SAPC - 2785 Copy / of 6

| 25X1A | 13 December 1955  |       |
|-------|---|-------|
|       | SUBJECT: Specification of $9\frac{1}{2}$ " Continuous Printer Printing Drum.  |       |

| 25X1A | 13 December 1955  |       |
|-------|---|-------|
|       | Attachment:<br>Sketch a/s in para 2.  |       |

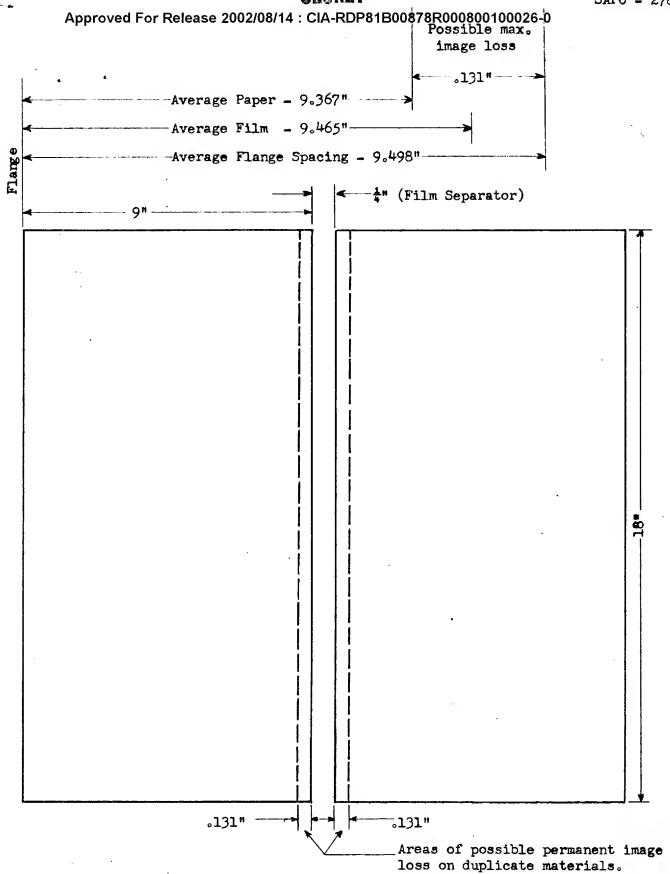
| 25X1A | 13 December 1955  |       |
|-------|---|-------|
| Ú     | 2. The earlier discussions were initiated to determine the feasibility of providing a protective edge on duplicate material from the B and C cameras. This edge is still desirable better   |       |
| 25X1A | dimensions provided by indicate a possible loss of image area in the preparation of duplicate material. The attached sketch indicates the possible loss of image which may occur. The loss of any image area is felt to be very serious and should be prevented if at all possible. |       |

$\left(\frac{.131}{12}\right) \times 2 \times \frac{70.000}{(36/12)} = 509^{\circ} = \text{Possible loss of coverage in duplicate}$ Approved For Release 2002/08/14: \*\*PCIA\*\*\* REDP 8 \*\* B00878 R000800100026-0

| 25X1A | 13 December 1955  |       |
|-------|---|-------|
|       | 3. It is recommended that Eastman Kodak be contacted to determine the feasibility of altering the printing equipment so as to insure the retention of all image area of the negatives from the B and C configurations.  |       |
